Facility/Subdivision Name: MONTGOMERY AUTO SALES PARK Preliminary Plan Number: 1-04101

DATE: 1-24-06
TO: PLANNING BOARD, MONTGOMERY COUNTY
VIA:
FROM: CAPTAIN JOHN FEISSNER 240.777.2436
RE: APPROVAL OF ~ *MONTGOMERY AUTO SALES PARK PLAN #8-06001 & 8-06002/SITE PLAN DATED AUGUST, 05*

Re: Montgomery County
Intercounty Connector
Montgomery Auto Sales Park (8-06001 & 8-06002)

SUBJECT: Preliminary Plan 120041010 and Site Plan Number 820060010,
Montgomery Auto Sales Park, Lot 17

CORRIDOR 1
CHECK IMPACTS TO
MONTGOMERY AUTO
SALES PARK REDEVELOPMENT

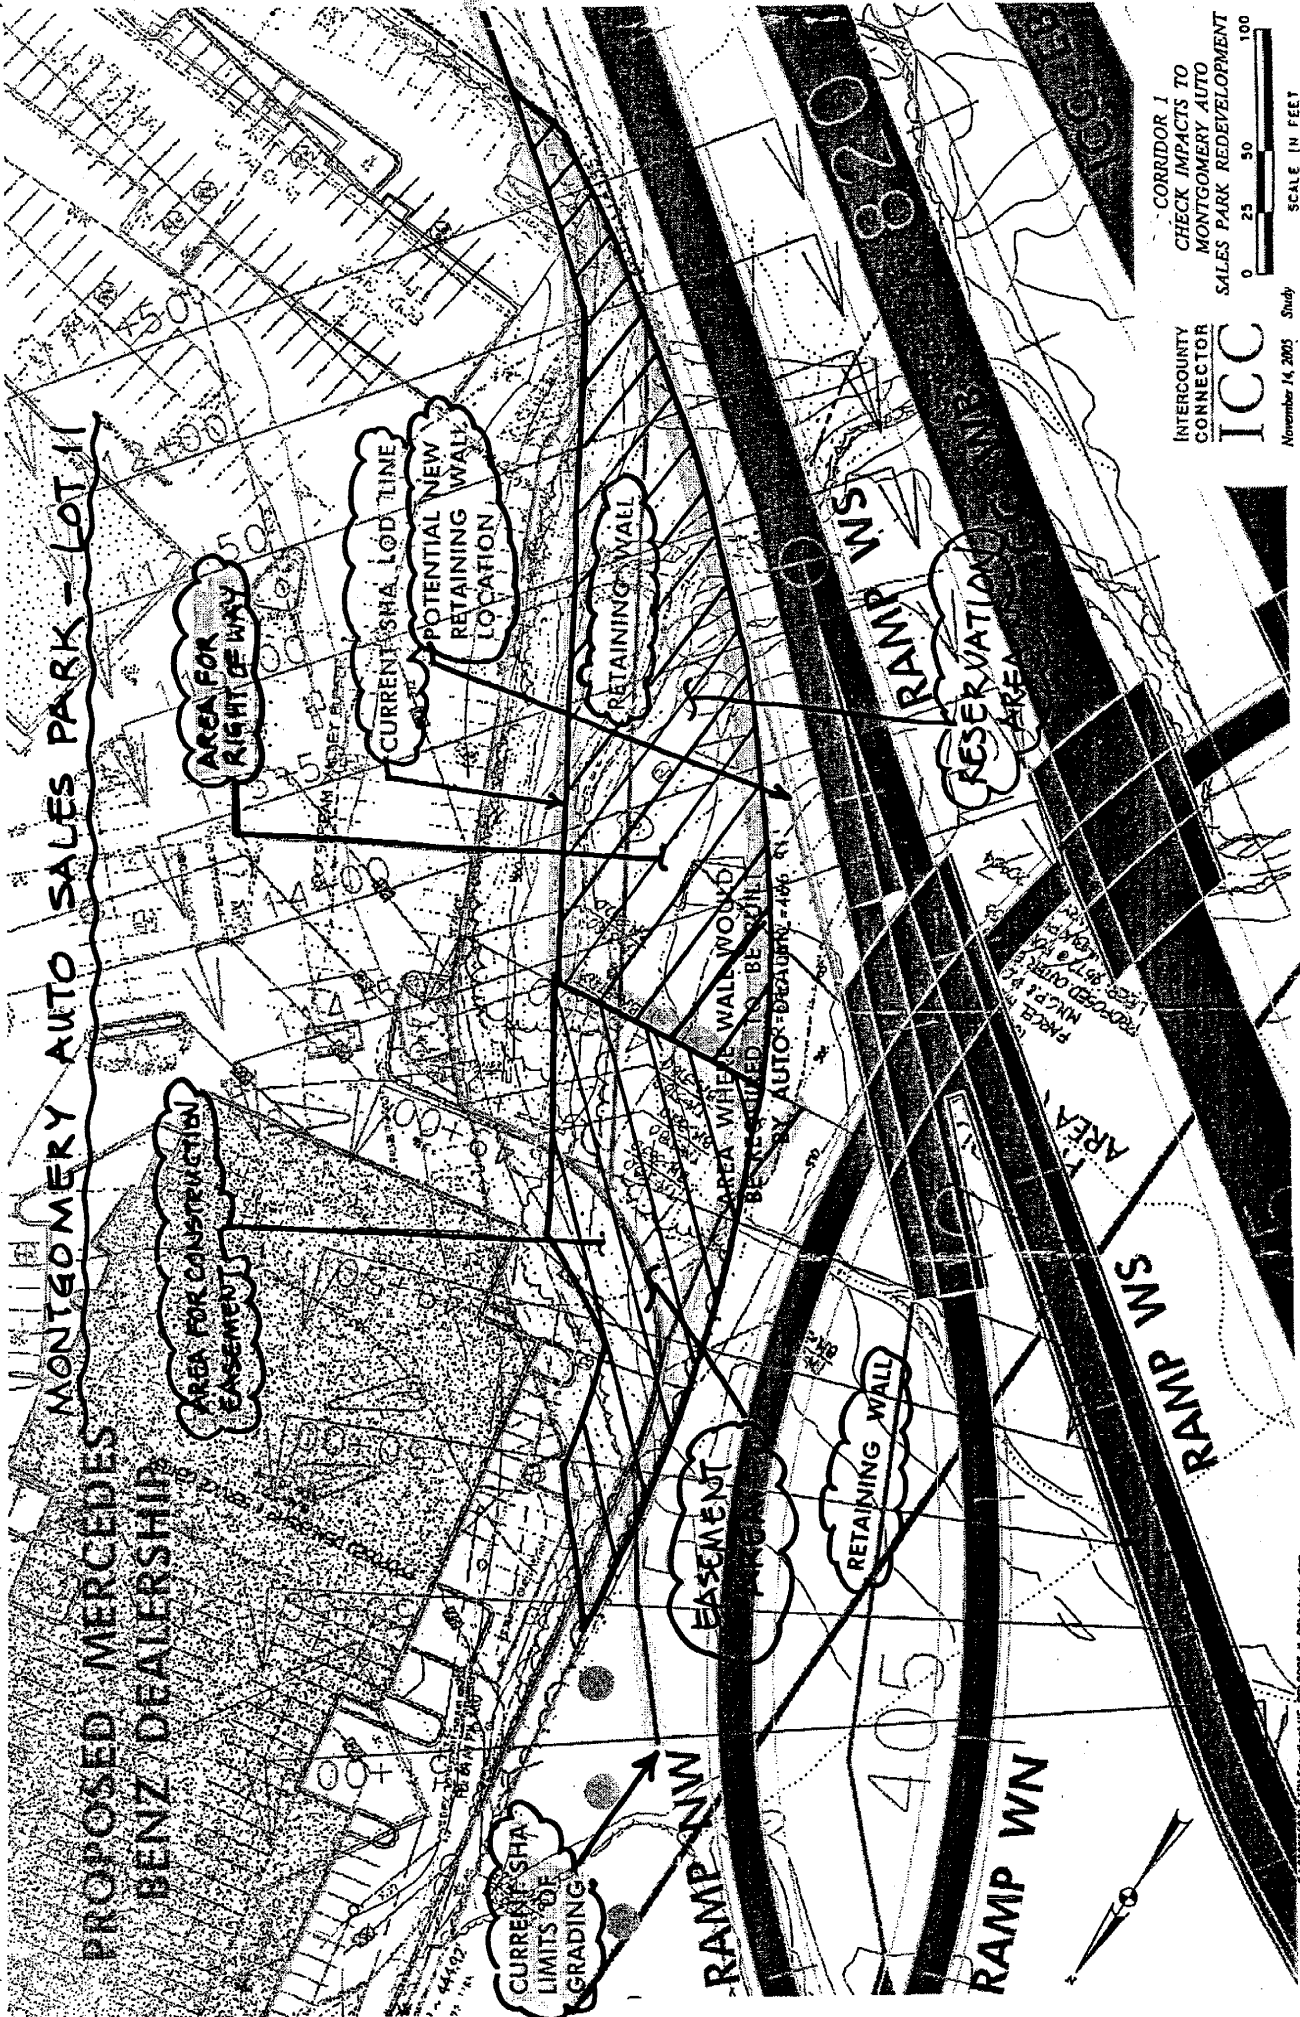
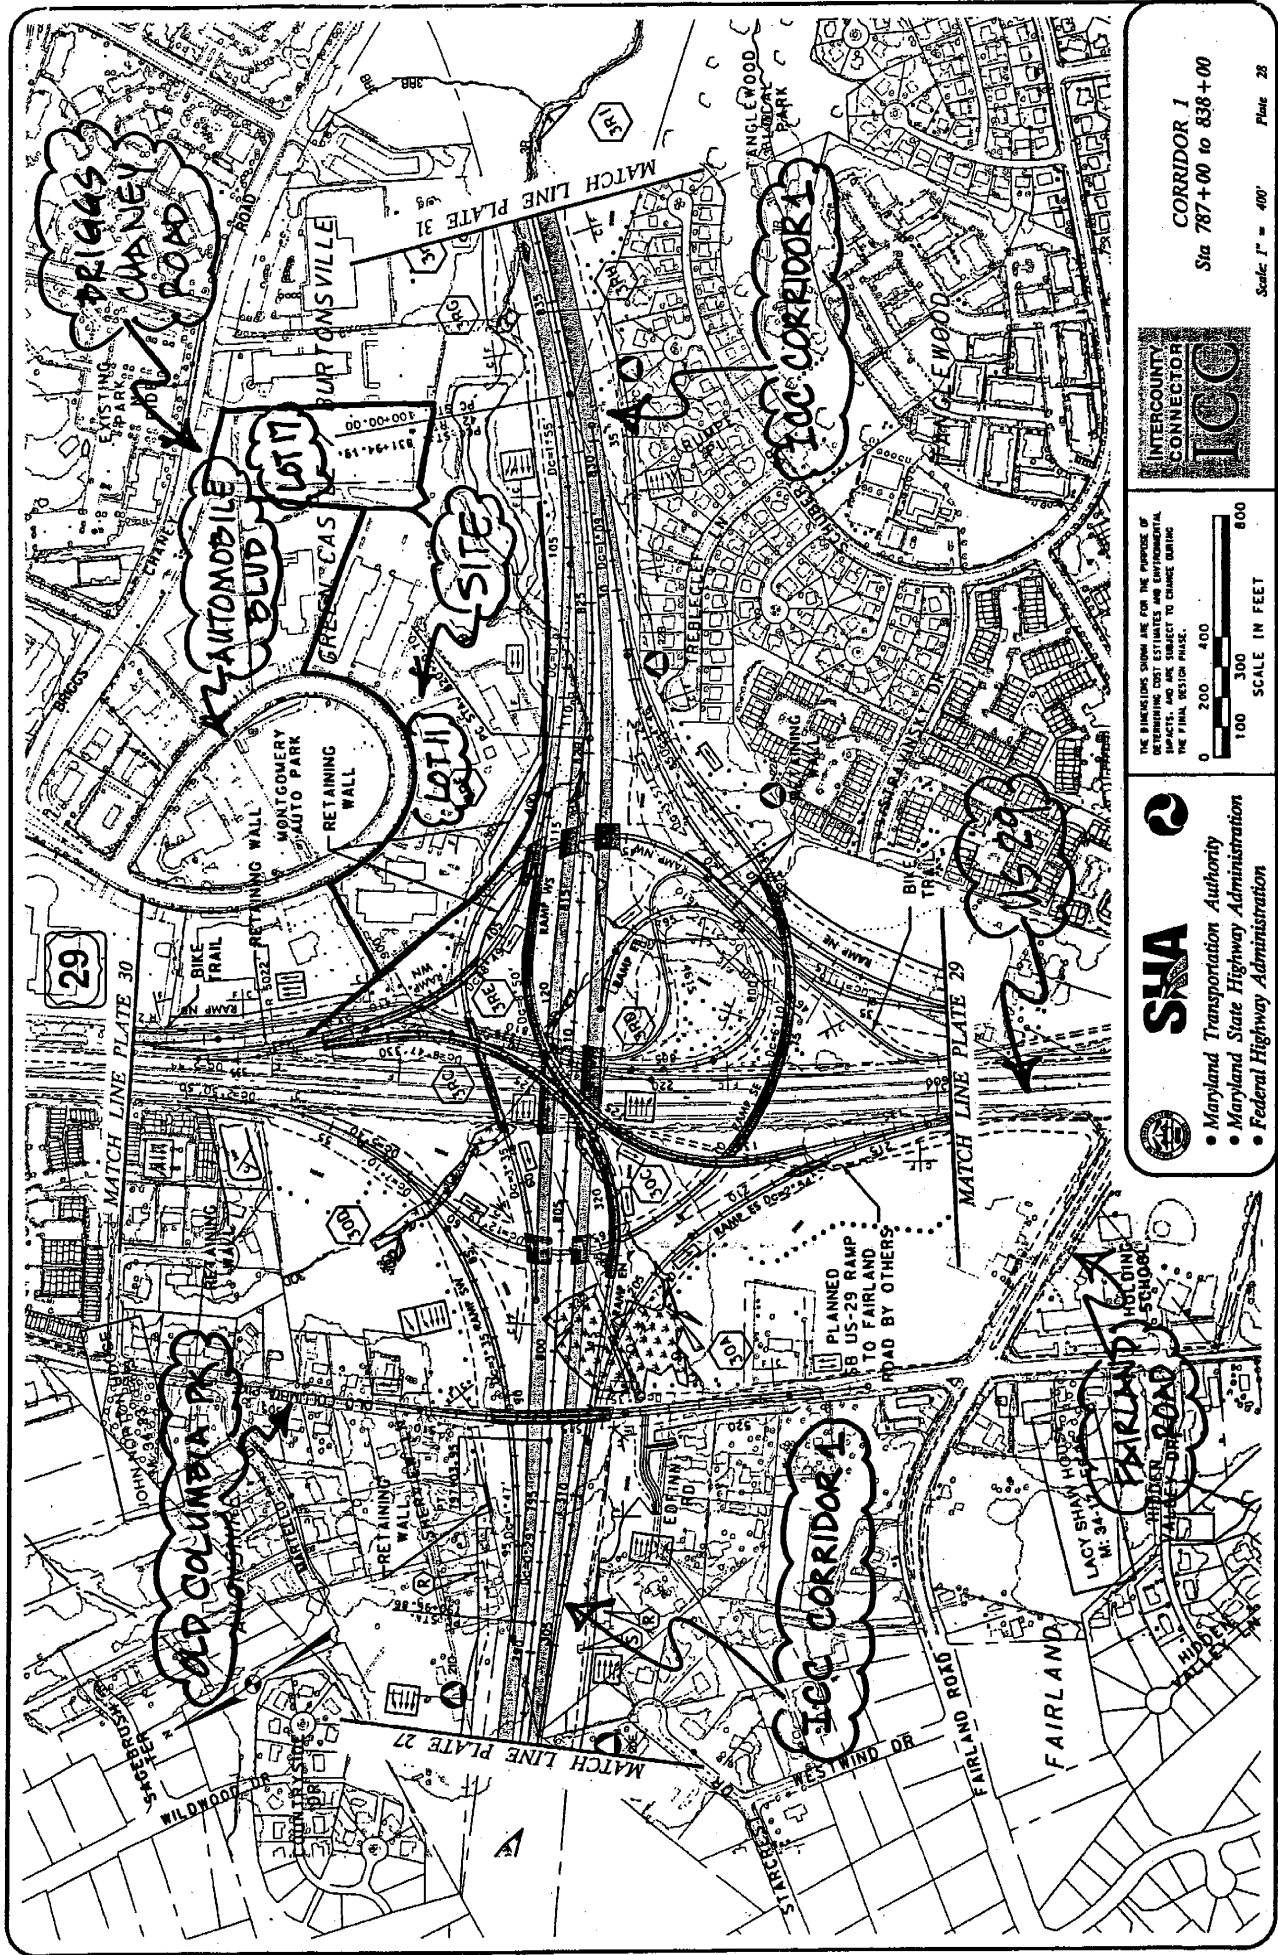
The Intercounty Connector (ICC) Corridor One, as shown to date, impacts about 0.80 acres of the property, as shown on the attached map. About 0.29 acres of this impact (highlighted in purple on the attached map), located right station 48+50 to right station 50+55 along ramp "NW", is due only to grading for supporting slopes, and could be handled as an easement. The remaining 0.51 acres of impact (highlighted in orange on the attached map) contains a potential retaining wall, and needs to be acquired as right-of-way.

To protect property that will support the State Highway Administration/Maryland Transportation Authority (SHA/MdTA) locally preferred alternative, Corridor One, which is being studied as part of the current National Environmental Policy Act process for the project, we request that your agency require reservation of this property through the project's Record of Decision scheduled for release on April 1, 2006. In addition, we request that the Site Plan approval be made contingent upon the owner continuing to work with the SHA regarding grading and drainage to make certain that neither the owner's or SHA's interests are precluded by the other.
